Subject: Response to Request for Additional Information - Generic Letter 96-06, "Assurance of Equipment Operability and Containment Integrity During Design Basis Accident Conditions," for Indian Point Unit No. 2. (TAC No. M96822)

RESPONSE TO REQUEST FOR ADDITIONAL INFORMATION
REGARDING RESPONSE TO GENERIC LETTER 96-06

Consolidated Edison Company of New York, Inc.
Indian Point Unit No. 2
Docket No. 50-247
September 1998

General Schematic of FCU Service Water Piping

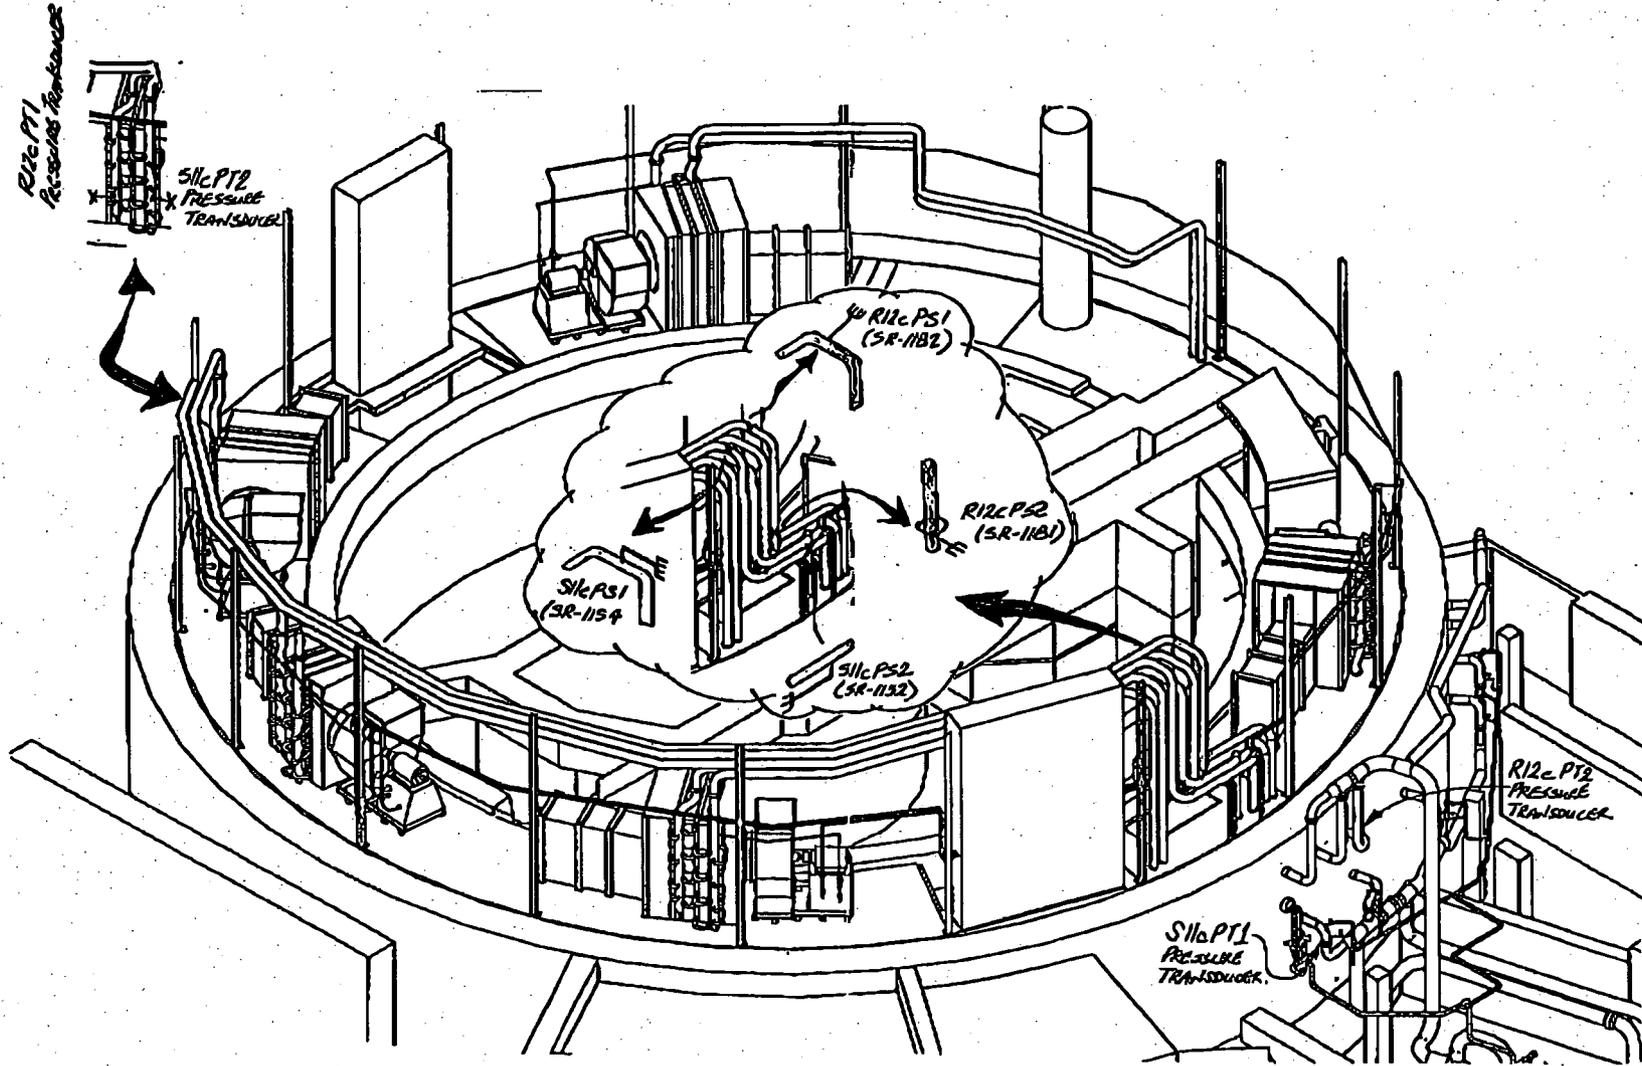
Provide a simplified diagram of the system, showing major components, active components, relative elevations, lengths of piping runs, and the location of any orifices and flow restrictions.

See attached figures (4).
